STATE OF MAINE
DEPARTMENT OF TRANSPORTATION
16 STATE HOUSE STATION
AUGUSTA, MAINE 04333-0016

January 18, 2019
Subject: Bridge Replacements &
Highway Construction
State WINs: 017280.00, 017912.00,
021691.00 & 023849.00
Location: Fryeburg
Amendment No. 1

NEXT F BEAM PART REINFORCING ELEVATION
Top flange longitudinal mild reinforcing not shown for clarity

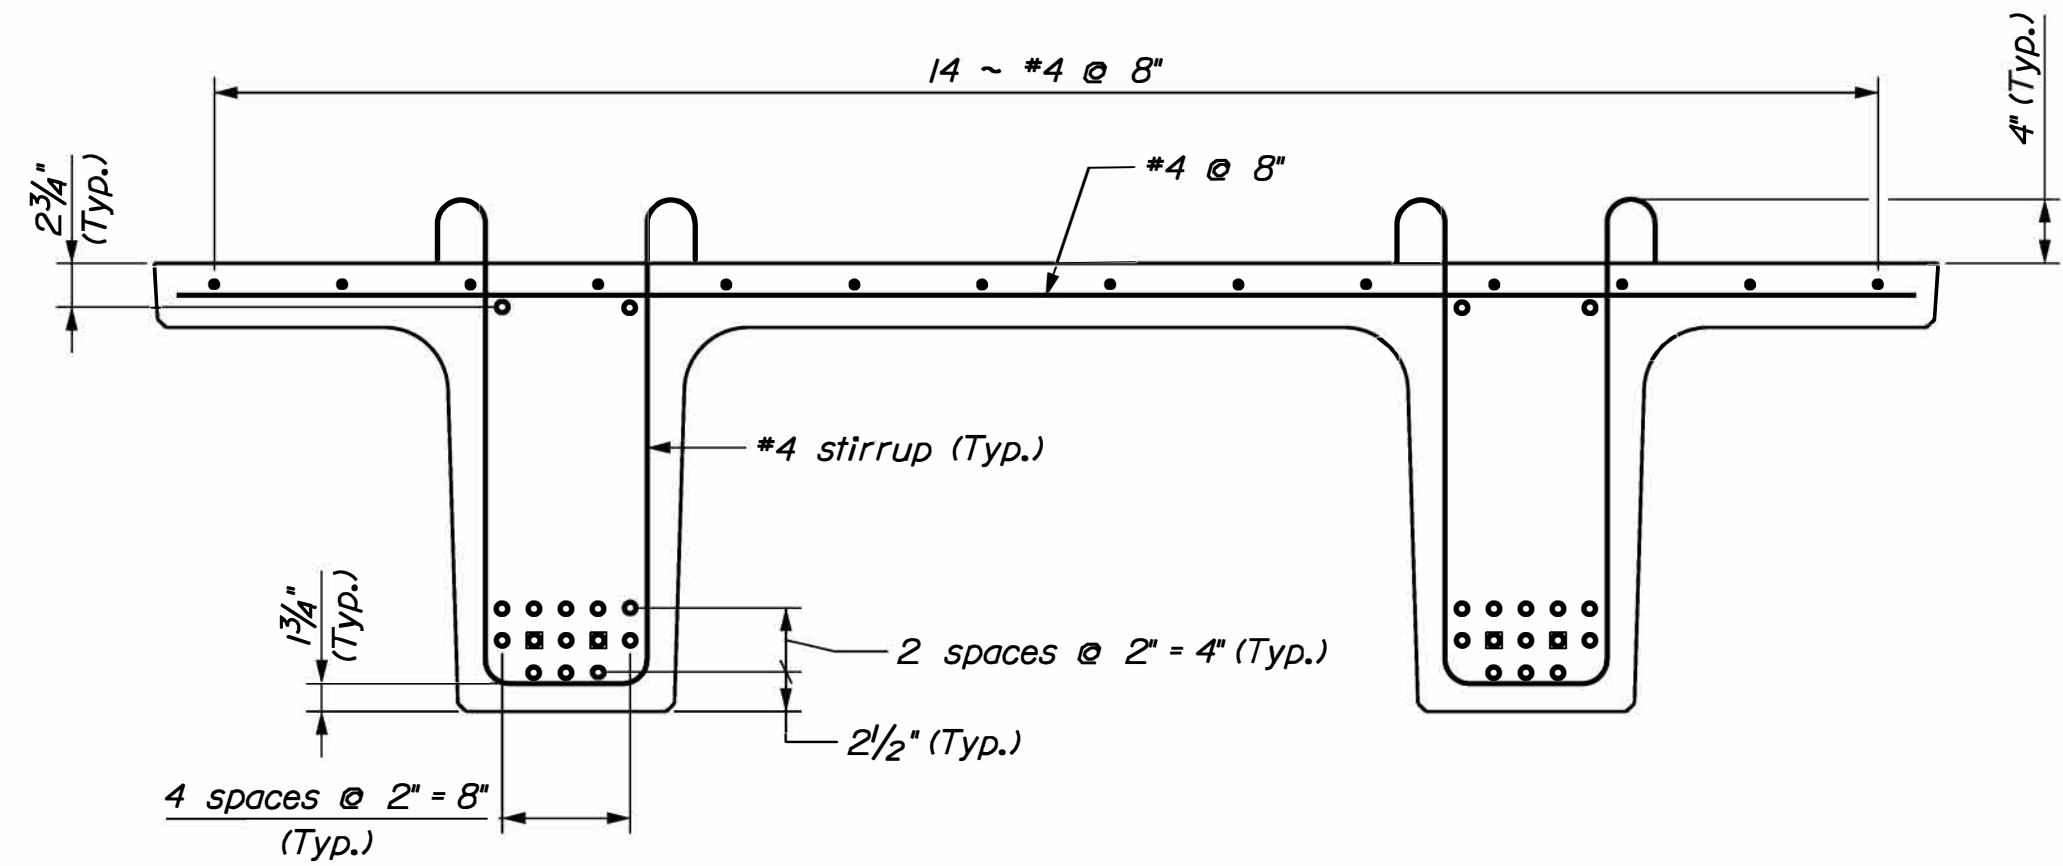
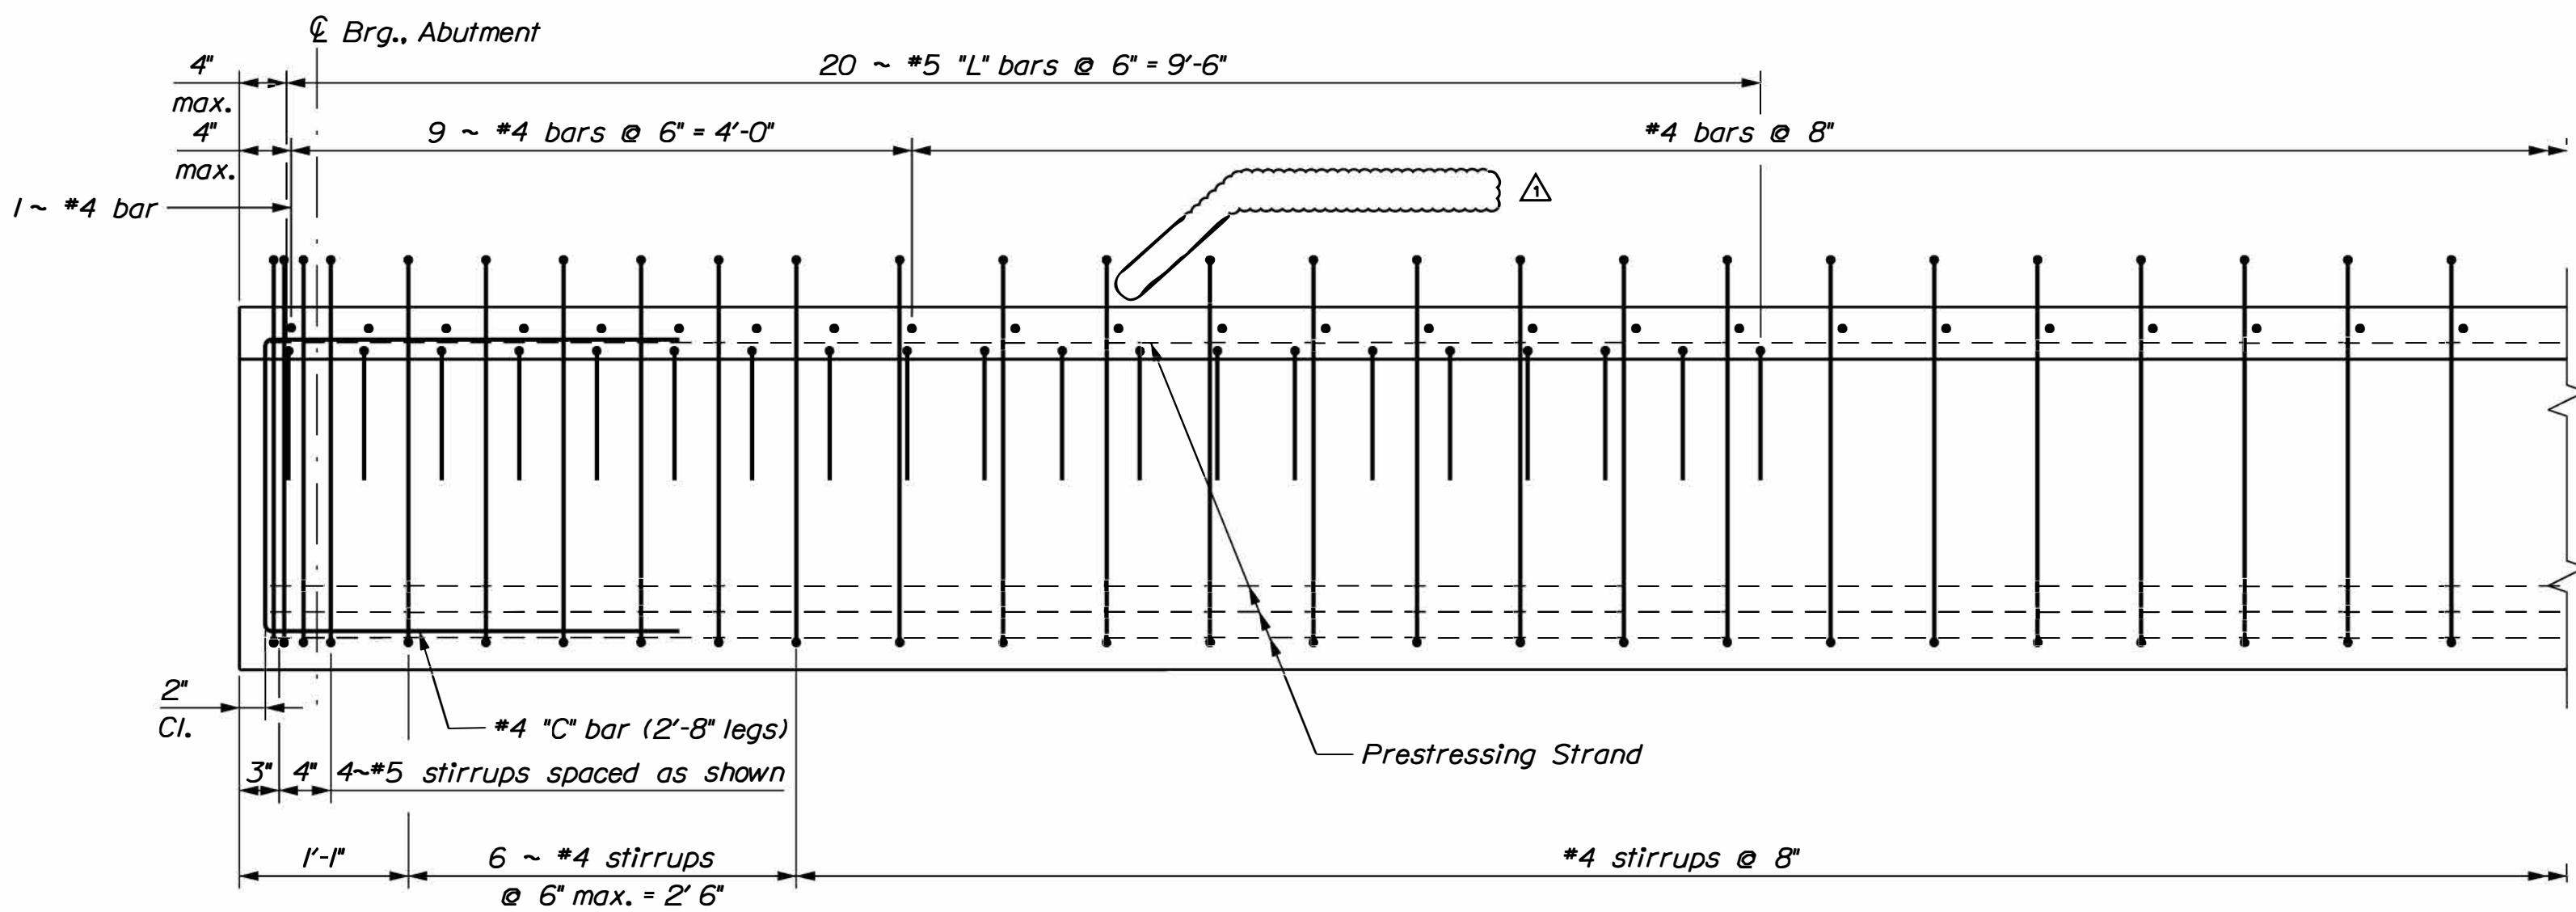
Question: On Sheet B19 of B22 in Detail "NEXT F Beam Part Reinforcing Elevation" there is a note indicating #4 bars that are 10'-0" long. Are these in addition to the full beam length mild reinforcing in the top flange? And if so, how many of these bars are required?

Response: No, see above changes to the Bid Documents.

NEXT 28 F BEAM TYPICAL SECTION - AT ENDS

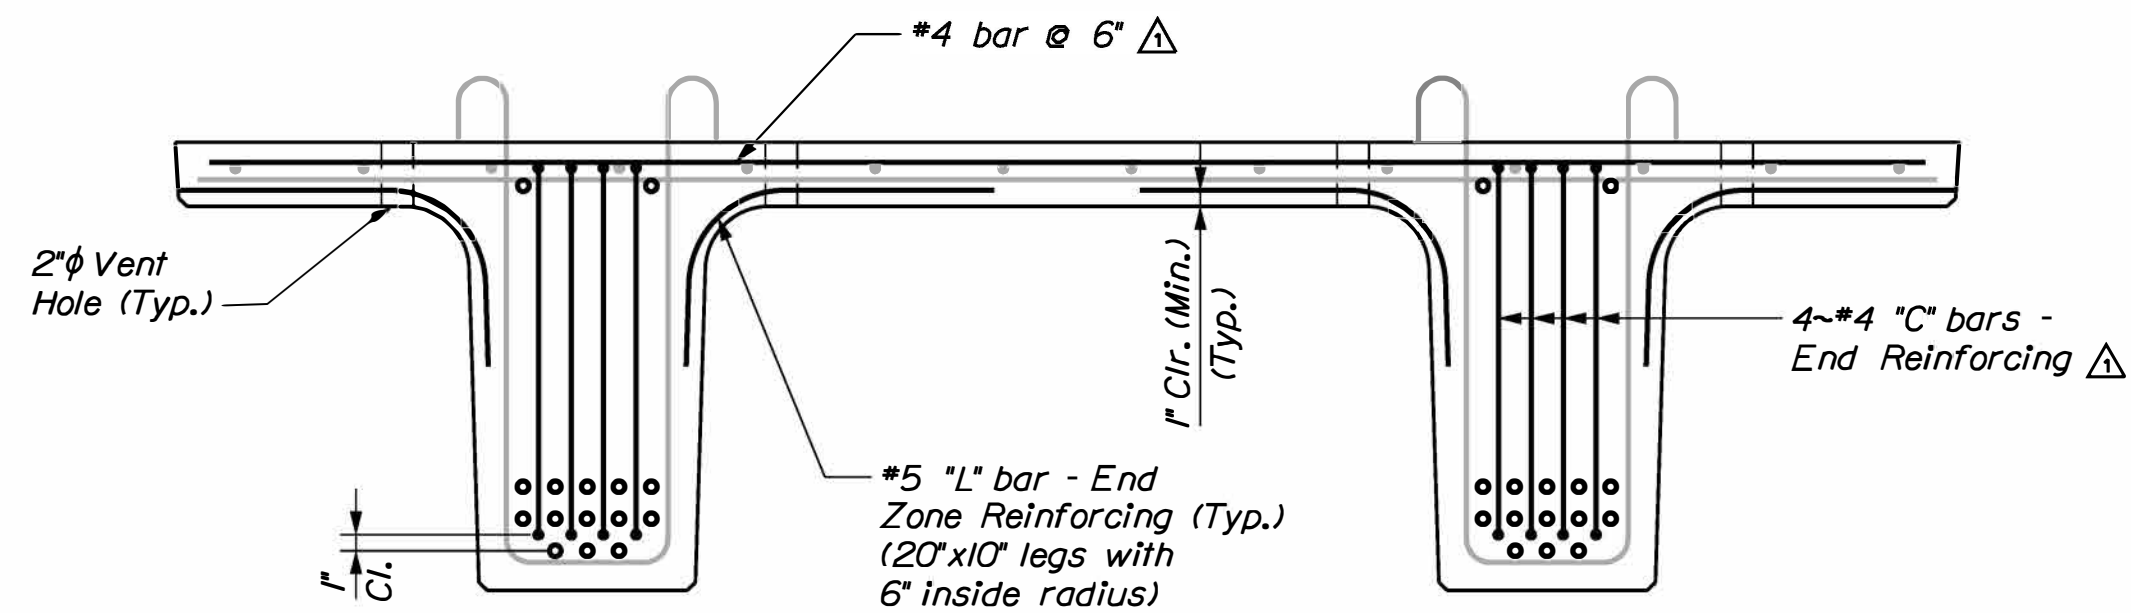
Question: On Sheet B19 of B22 in Detail "NEXT 28 F Beam Typical Section - At Ends" there is a note saying "#4 bar @ 6" - End Zone Reinforcing". This detail seems to show that there will be a second layer of #4 bars in the end zone that isn't shown in other details on the page. If this second layout of straight bar is required at 6" what is the end zone distance these bars need to be included for?

Response: The transverse top flange reinforcement is spaced at 6 inches for a distance of 4 feet from the end of each beam. The spacing for the rest of the top flange transverse reinforcement is 8 inches. Please see the above changes to the Bid Documents.

PROJ. MANAGER	J. STILLWELL	BY	DATE
DESIGN-DETAILED	R.M.	D.B.V.S.F.	DEC. 2018
CHECKED-REVIEWED	J.S.	S.W.	DEC. 2018
DESIGN-DETAILED			
REVISIONS 1	Remove End Zone Ref's		1-10-19
REVISIONS 2			
REVISIONS 3			
REVISIONS 4			
FIELD CHANGES
